Date: November 6, 2002
 To: T10 Technical Committee
 From: Alvin Cox (alvin.cox@seagate.com)
 Subject: SAS Test Loads

The following changes to text and test load figure are made to aid the testing process by clarifying and defining the compliance interconnect test load and zero-length test load. The changes to the rev 0 version are significant and not highlighted in an effort to make this version more readable. Revision 2 adds a statement explaining the purpose of compliance interconnect testing. Revision 3 adds additional changes to section 5.7 as agreed upon during the face-to-face 11/4-11/5.

Figure 39 — Transmitter test loads

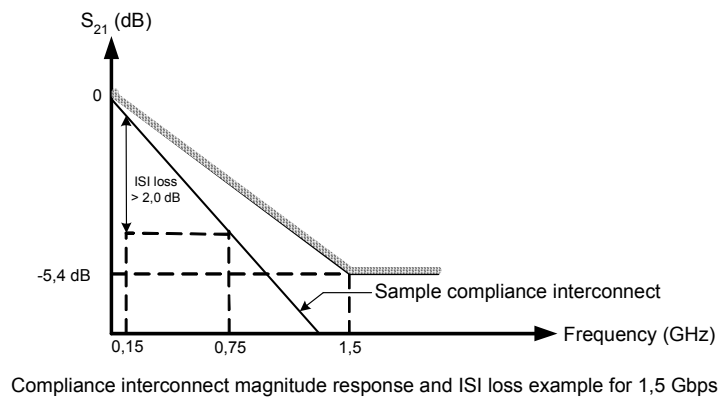
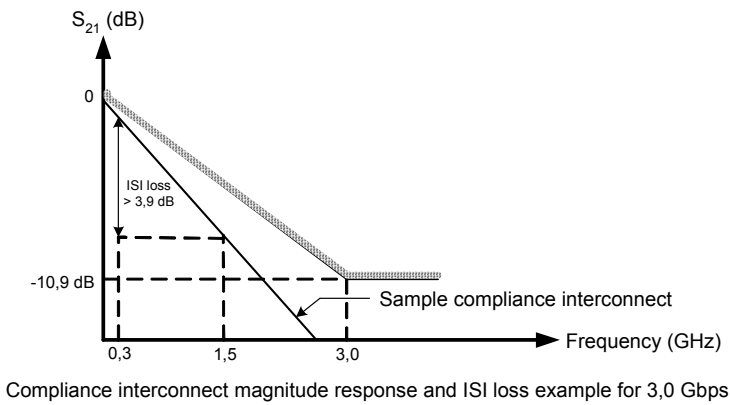
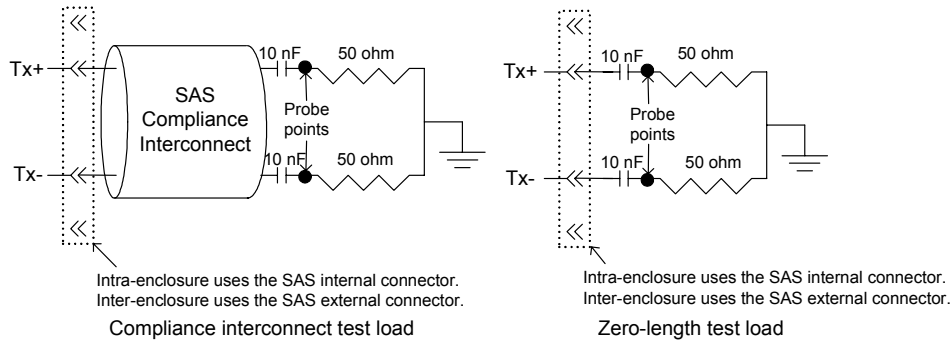
A combination of a zero-length test load and the transmitter compliance transfer function (TCTF) test load methodology is used for the specification of the initiator, expander or target device transmitter characteristics. This methodology specifies the transmitter signal at the test points on the required test loads. The transmitter shall use the same settings (pre-emphasis, voltage swing, etc.) with both the zero-length test load and the TCTF test load. The received signal specifications shall be met under each of these loading conditions.

The TCTF is used to specify the requirements on transmitters that may or may not incorporate pre-emphasis or other forms of compensation. A compliance interconnect is any physical interconnect with equal or greater loss at all frequencies than that required by the TCTF.

Compliance with the TCTF test load requirement shall be determined either (a) by measuring the signal produced by the transmitter through a physical compliance interconnect attached to the transmitter or (b) by mathematically processing through the TCTF the signal captured using a zero-length test load.

Compliance with the zero-length test load requirement shall be determined by measurement made across a load equivalent to the zero-length load shown in figure 39.

The compliance interconnect magnitude response and ISI loss examples for 3 Gbps and 1,5 Gbps are shown in figure 39.
